1 **SUPPLEMENTAL REPORT OF PROFESSOR G. MATHIAS KONDOLF, PH.D.**

2
3 I was asked by Natural Resources Defense Council to review the expert reports of Drs.
4 Charles Hanson, Michael Harvey, Rod Wittler, Clair Stalnaker, Don Smith and Joseph
5 Kubitschek regarding the flow and non-flow measures necessary to restore salmon fisheries to
6 good condition in the San Joaquin River below Friant Dam. I address three topics below: (1)
7 uncertainty regarding the impact of a restoration flow schedule on these fisheries, (2) the
8 magnitude of the flow schedule, and (3) non-flow measures necessary to restore these fisheries
9 to good condition.

Figure 1. Comparison of Kondolf and Hanson Recommended Dry Year Restoration Flows at Friant Relative to Average Calculated Dry Year Unimpaired (1896-1999)

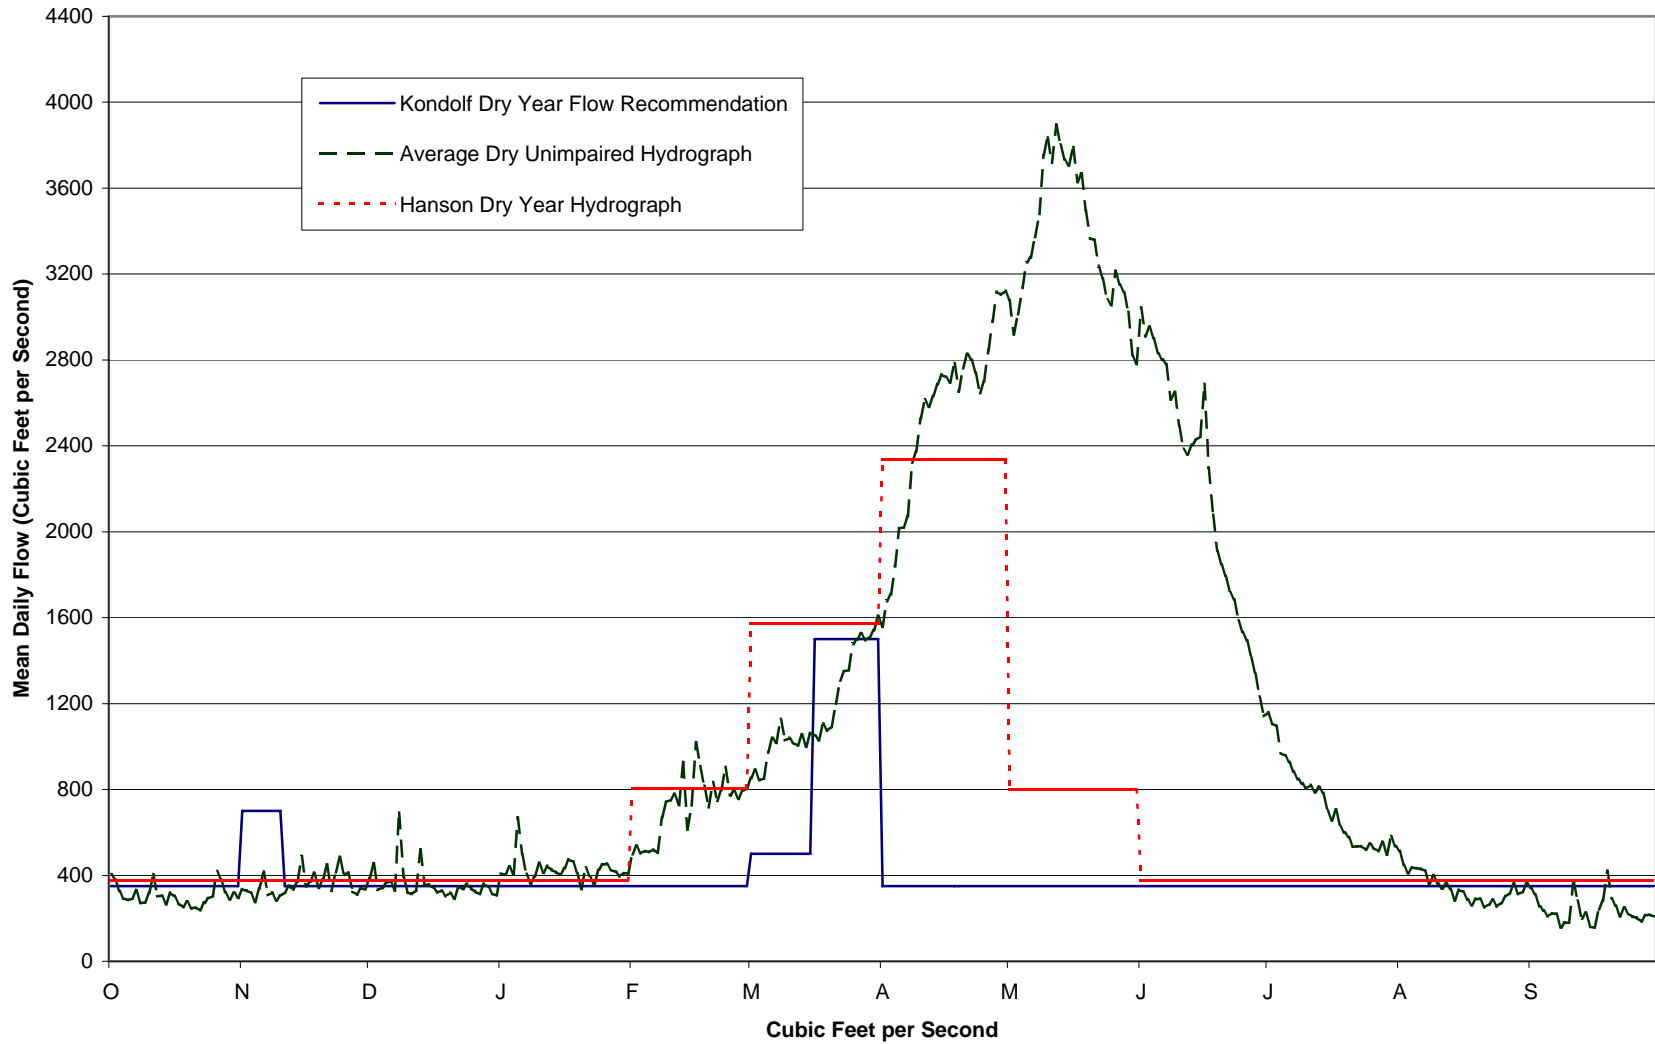
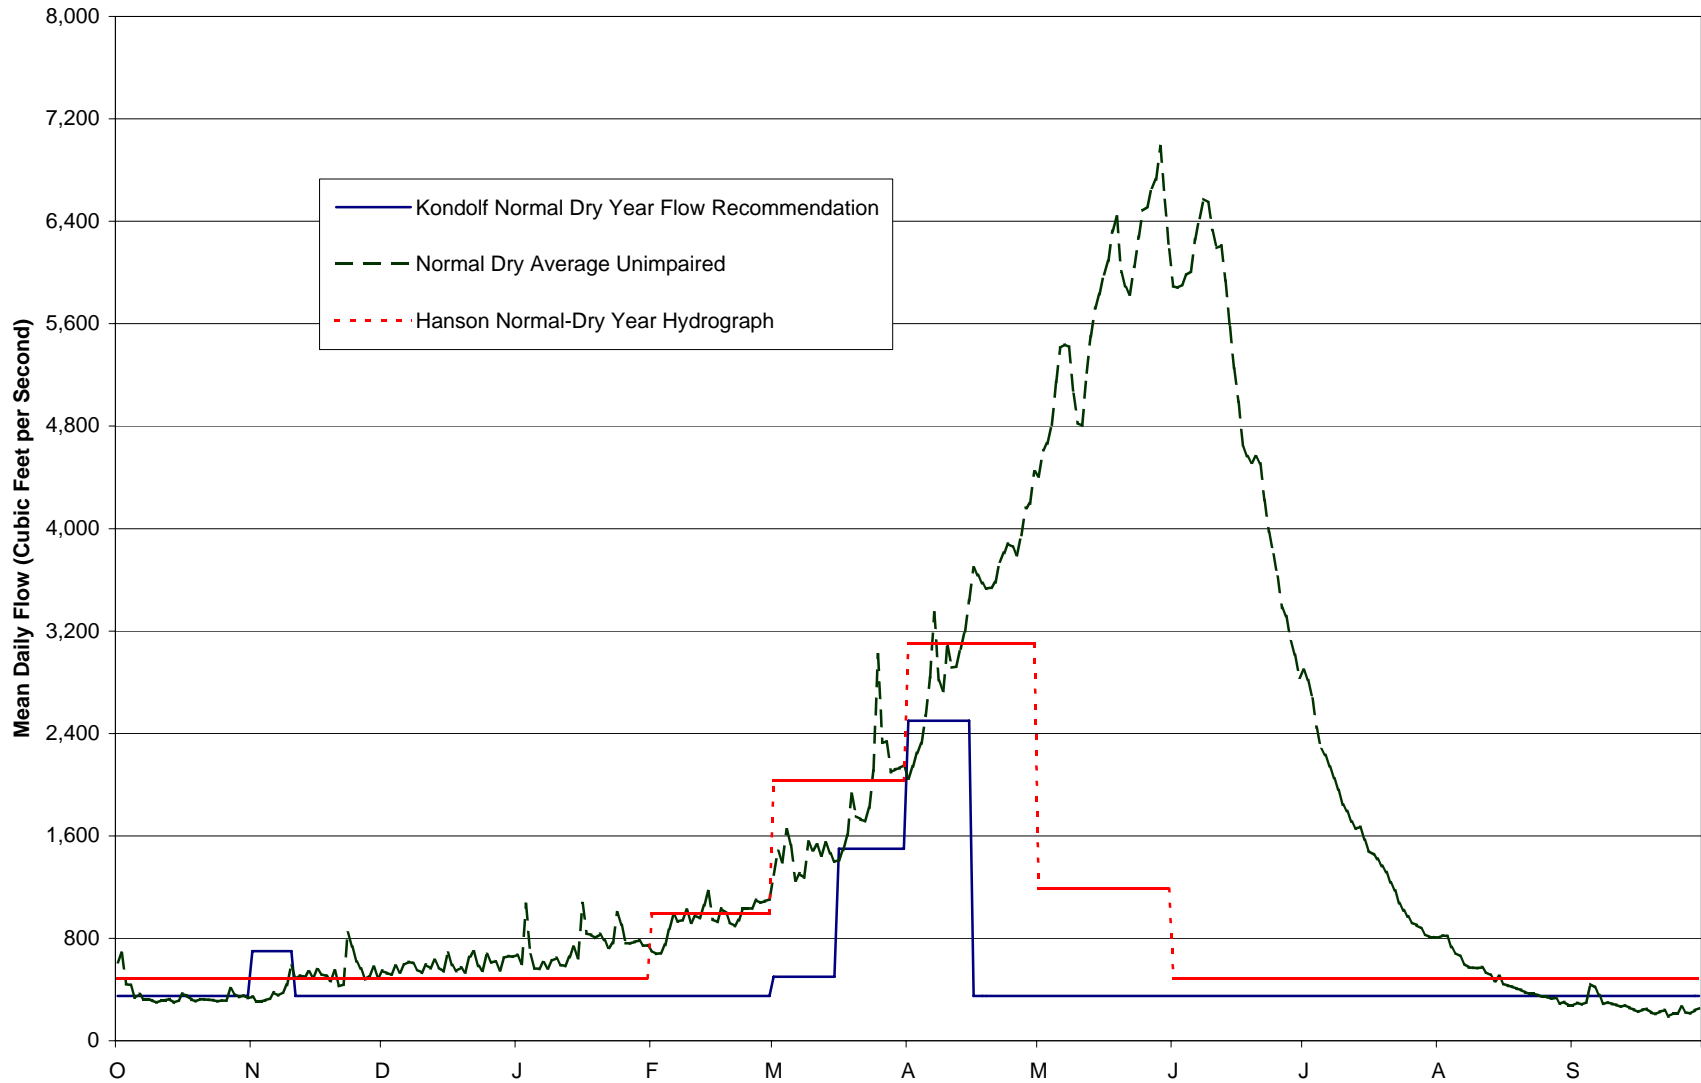
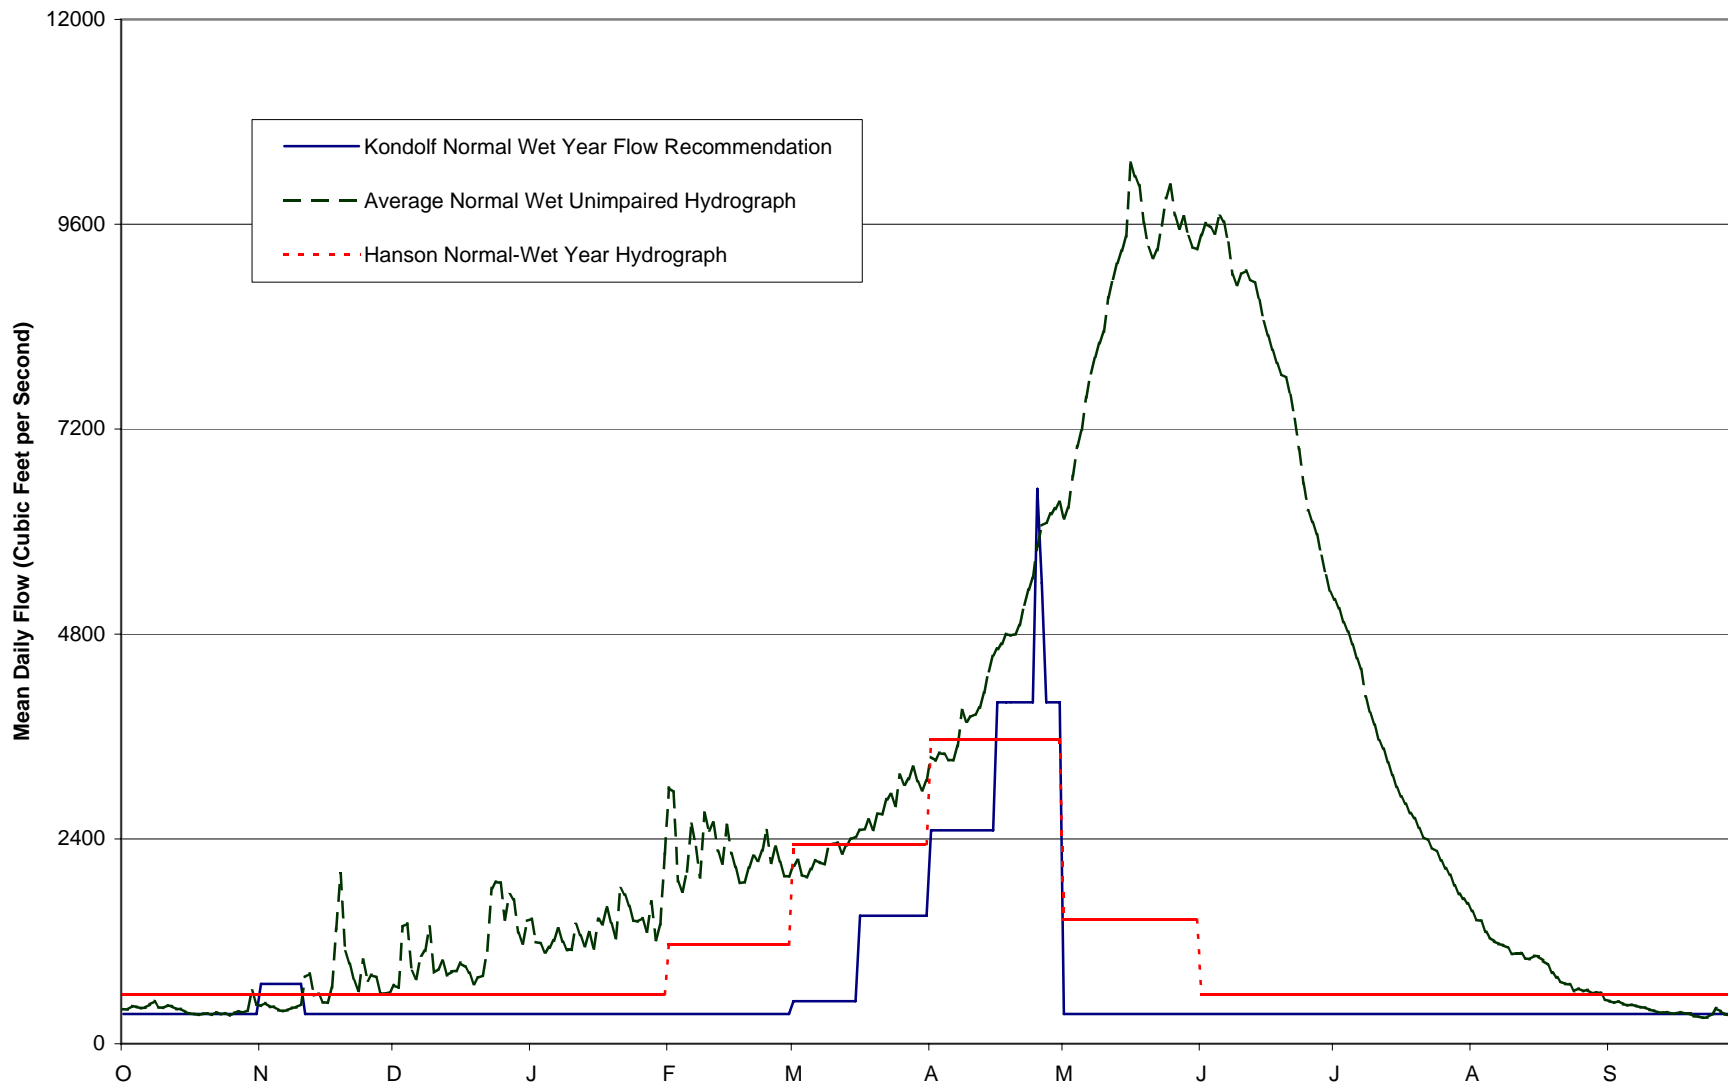
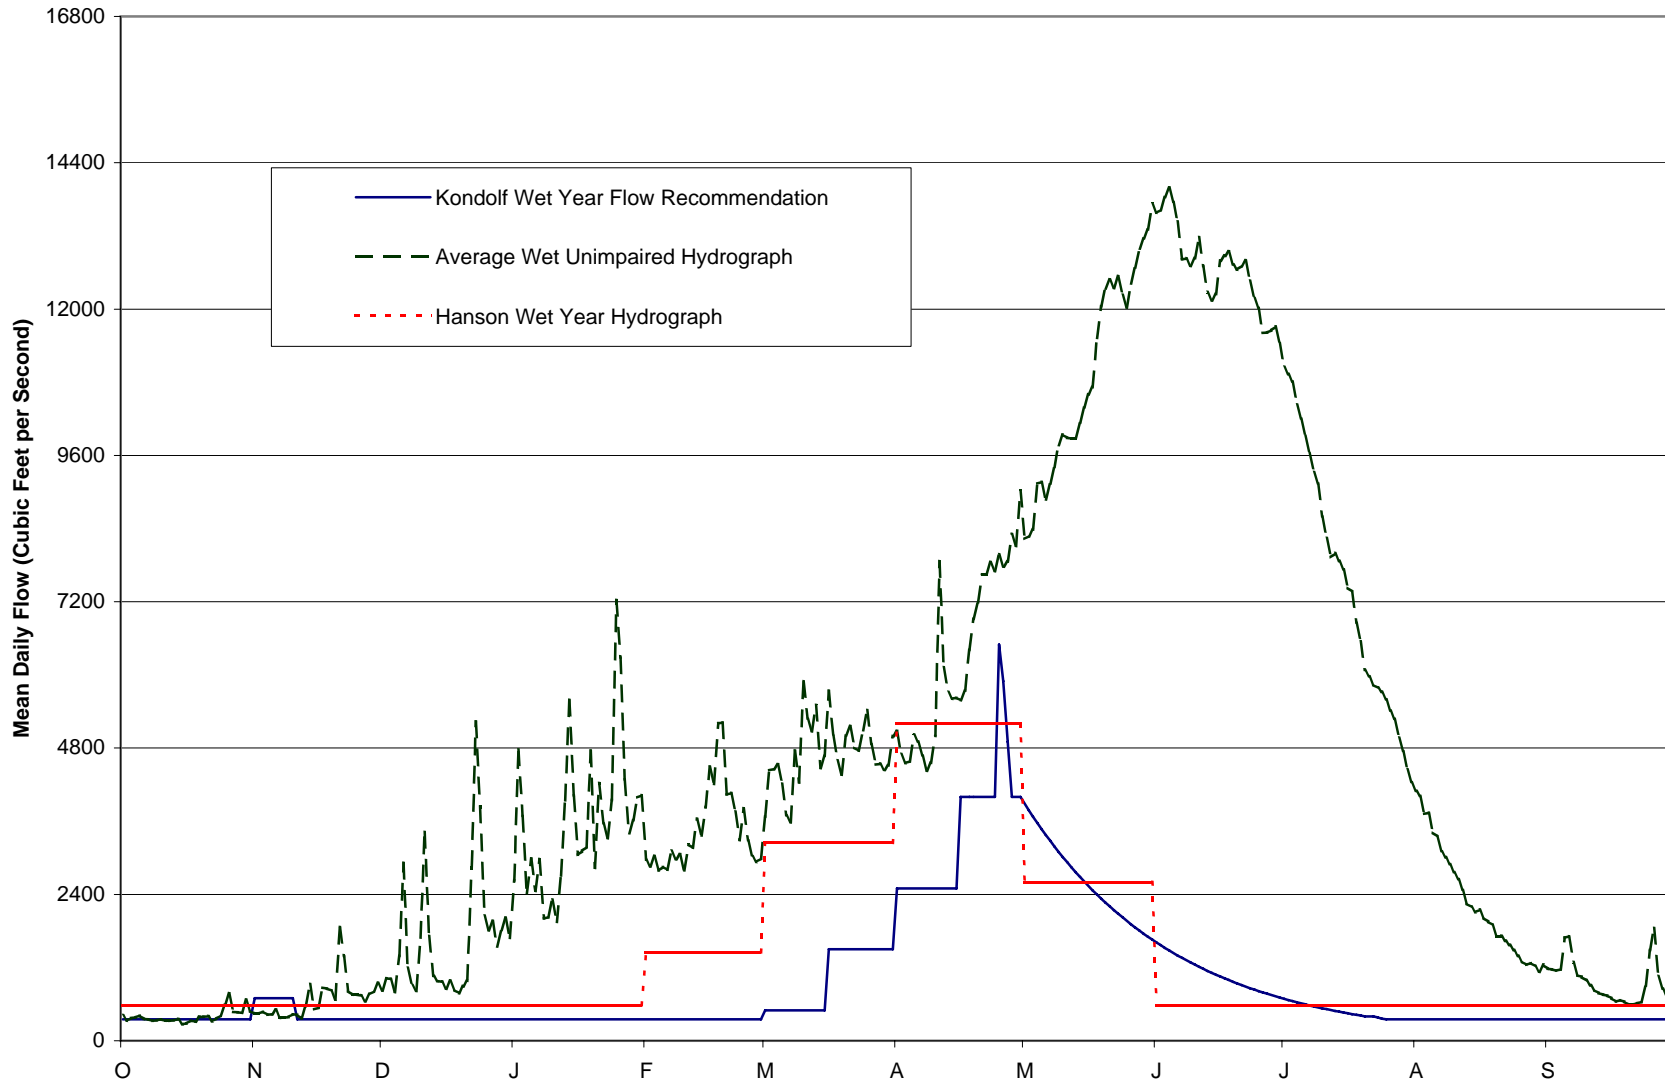
- 20 17. Specifically, for all year types, Dr. Hanson's restoration hydrograph overstates:
21 a. the magnitude of base flows needed to restore and maintain salmon during
22 the late spring through late winter months,
23 b. the amount of flows necessary for upstream and downstream salmon
24 migration in February and early March,
25 c. the volume of water necessary between mid-march and late April necessary
26 to maintain temperature and otherwise support migration of juvenile and
27 adult salmon, and
28 d. the amount of water necessary to ramp flows down from the spring pulse to
the summer base flow.

1 18. Figure 1 (end) illustrates the excess water for each of these hydrograph
2 components which cumulatively result in restoration flow volumes that on average result in
3 more than 1.7 times more flow than I recommended for salmon restoration in my previous
4 report. Furthermore, since Dr. Hanson's hydrograph lacks a critical year category, his dry
5 year recommendation requires over 3 times more water on average than the critical dry year
6 recommendation I provided in my report. Perhaps the key difference is that Dr. Hanson
7 proposes to restore the San Joaquin River to a largely unimpaired condition, whereas Dr.
8 Moyle and I propose reconciliation, in which we restore anadromous salmon, while still
9 allowing diversions to support other human uses.
